Date	April 15, 2021
То	Town of Cumberland Planning Board
From	Carla Nixon, Town Planner
Subject	Planning Board Site Plan Review – Mill Run - Phase 3 Office Building

Subject: Peer Review for Site Plan Application Professional Office Building -West Cumberland Mill Run Condominiums Unit 3 Route 100, Cumberland, Maine

RE: West Cumberland – Phase 3 Professional Office Building (Condominium Unit 3) Response to Peer Review Comments & Architectural Narrative

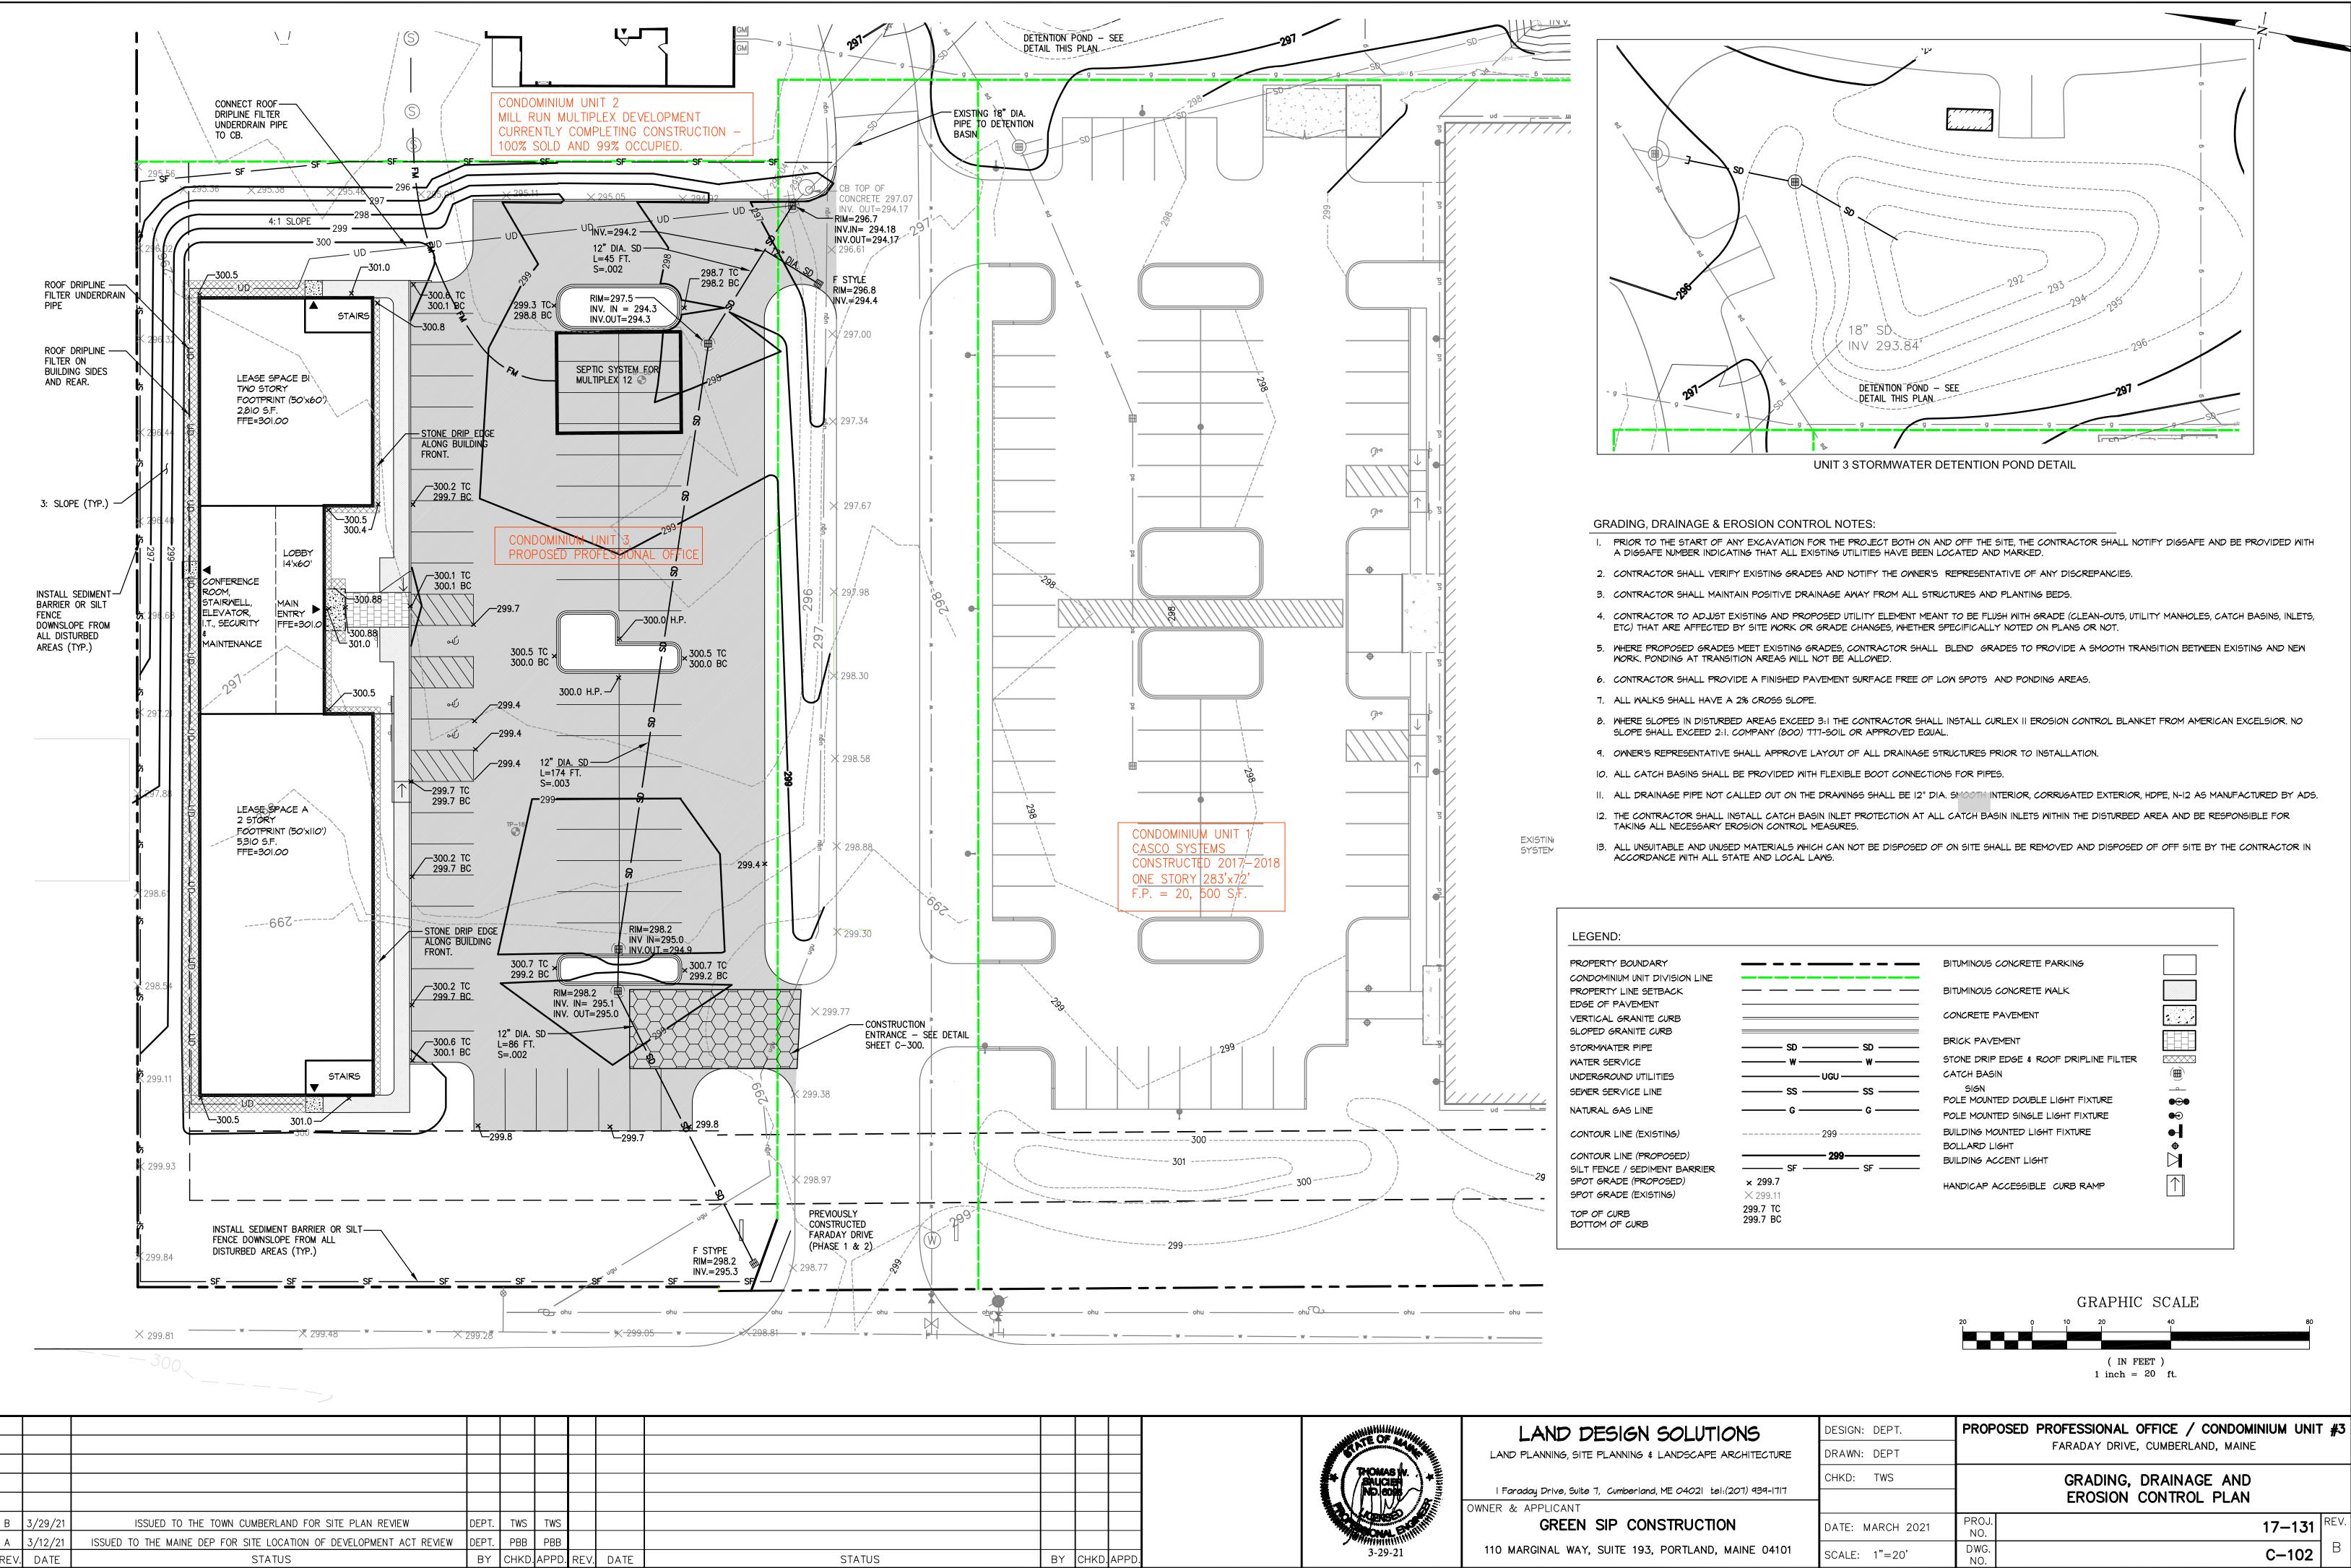
- 2. Please add an invert elevation and cleanout for the underdrain pipe for the Roof Dripline Filter on the plan drawings.
- 3. Please provide design details for the outlet control structure on Drawing C-102. There is no information provided on the partial plan.
- 4. SME recommends that riprap inlet and outlet protection be added to the pipes in the detention pond.
- 5. The total area accounted for at POI 1 in the Stormwater management Report is 11.467 acres in the Post-development model and 11.394 acres in the Pre-development model. Please revise to match, or explain the discrepancy.

- 3. Please provide design details for the outlet control structure on Drawing C-102. There is no information provided on the partial plan. The design details will be added to the outlet control structure shown on the partial plan view on drawing C-102.
